MONTGOMERY COUNTY HISTORIC PRESERVATION COMMISSION
STAFF REPORT

Address:	7102 Poplar Ave., Takoma Park	Meeting Date:	7/12/2023
Resource:	Non-Contributing Resource Takoma Park Historic District	Report Date:	7/5/2023
Applicant:	William Ince & Mary Henderson Brian McCarthy, Architect	Public Notice:	6/28/2023
Review:	HAWP	Tax Credit:	Partial
Case No.:	1034682	Staff:	Dan Bruechert
Proposal:	Partial demolition, new construction, porch alterations

Figure 2: Existing front elevation (left) and proposed front elevation (right).

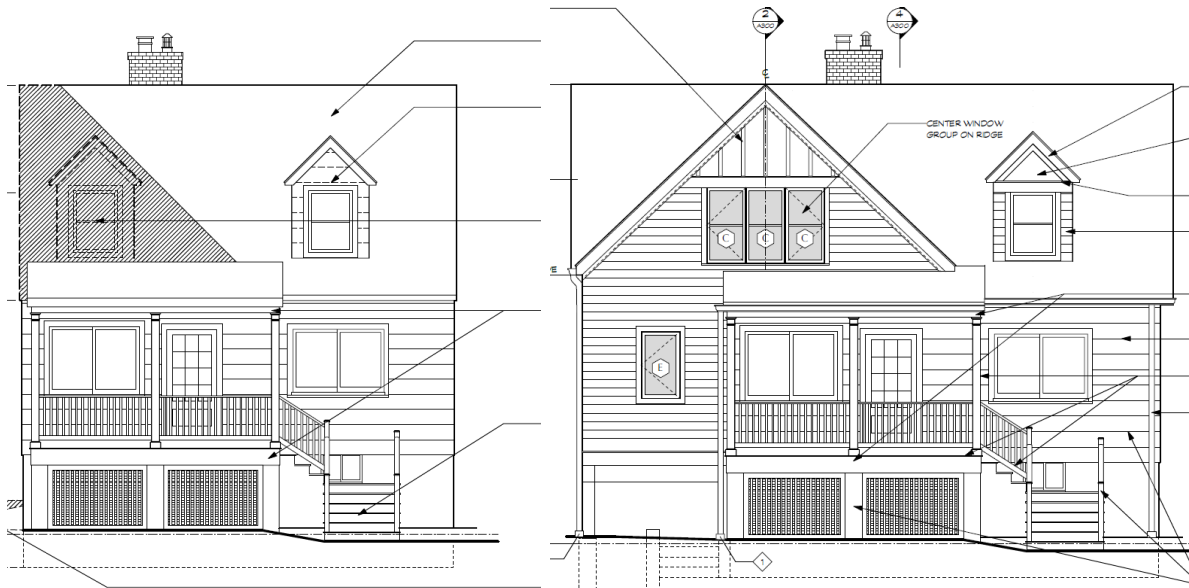
On the left (south) side of the front elevation, the applicant proposes to construct a two-story addition. The addition will be 8' (eight feet wide) and will have a large front gable dormer. The addition's front wall plane aligns with the existing front wall plane. The addition's setback to the south will shrink from 16' (sixteen feet) to 8' (eight feet). This addition will provide additional living space on the ground floor and an additional bedroom on the second story. The application materials indicate the large dormer was selected to "give the house a more appealing visual hierarchy." To unify the appearance of the two dormers, the applicant proposes to remove the siding on the right dormer and install fiber cement clapboards in a reveal matching the addition's proposed siding. The dormer roofing will be modified to accommodate a 6" (six inch) overhang.

On the south side of the house, there is an areaway that provides access to the basement. The proposed addition will block the existing access to the areaway. To maintain access to this areaway, the applicant proposes to remove the existing side-loading stairs and install a new set of front-loading concrete stairs to the left of the porch (see Figure 2, above). The new stairs will require minor re-grading, but will not be highly visible from the right-of-way because of the site's rise in grade from the street level. Material specifications were not included with the HAWP application. Staff finds this alteration will not have a significant visual impact on the character of the house or surrounding district and recommends the HPC approve the new exterior stairs under the *Design Guidelines*. The drawings showing the areaway need more detail to show how much of the proposed stairs and new wall will be visible from the public right-of-way. Staff recommends the HPC add a condition to the approval of the HAWP that detailed drawings of the proposed areaway stairway, including material specifications and final finished heights for the walls above grade, need to be submitted to Staff for review and approval before approval documents are released.

Staff finds the proposed fiber cement siding, wood clad casement and sash windows, and asphalt shingles are all compatible materials for additions and new construction in the Takoma Park Historic District. The applicant did not include a reveal for the proposed fiber cement clapboards. Staff recommends the HPC include a condition for approval that the fiber siding reveal needs to be submitted to Staff for final review and approval before the approval documents can be released; with final approval authority delegated to Staff. Staff finds the right dormer is not historically significant and removing and replacing its siding will not significantly impact the character of the house or the surrounding district. Also, as a 'Non-Contributing' resource, Staff finds this alteration will not impact the size or massing of the resource. Staff finds the proposed Staff additionally finds the proposed side addition significantly changes the house design and street front presence. The increased width notwithstanding, the larger dormer brings more of the house mass toward the street front. However, Staff finds the new design will not detract from the character of the district and is an aesthetic improvement from the house's current configuration. Staff recommends the HPC approve the left side addition under 24A-8(d) and the *Design Guidelines*.

1. Reveal of the fiber cement clapboards needs to be submitted to Staff for review and approval before approval documents are released. The reveal shall not exceed 6” and the clapboards shall have a smooth finish. Final approval authority is delegated to Staff.
2. Detailed drawings of the proposed areaway stairway, including material specifications, information on grading, and the final finished height of the walls above grade, shall to be submitted to Staff for review and final approval before approval documents are released.
3. Final review of the material specifications for the porch repairs is delegated to Staff to ensure appropriate materials and details.

Figure 3: Left side elevation showing the existing screened-in porch (left) and proposed rear addition (right).

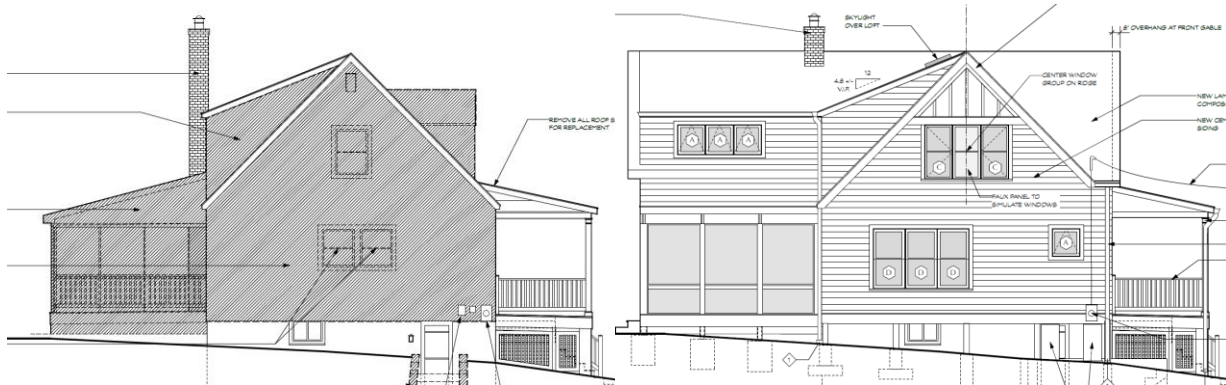
At the rear of the house, the applicant proposes to demolish an existing screened-in porch and construct a two-story rear gable addition above a screened-in porch. The siding will be fiber cement that matches the proposed side addition (discussed above) and will have wood clad casement windows with an asphalt

shingle roof. Additionally, four skylights are proposed on the rear roof slopes that will not be visible from the right-of-way.

Staff finds visibility of the proposed rear addition will be limited by the 8' (eight-foot) insets from each of the wall planes. Staff finds the materials proposed are consistent with approvals for building additions and new construction in the Takoma Park Historic District as discussed above. Staff additionally finds the proposed rear addition is modestly sized and will not overwhelm either the house or the surrounding streetscape. Staff recommends the HPC approve the HAWP under 24A-8(d) and the *Design Guidelines*.
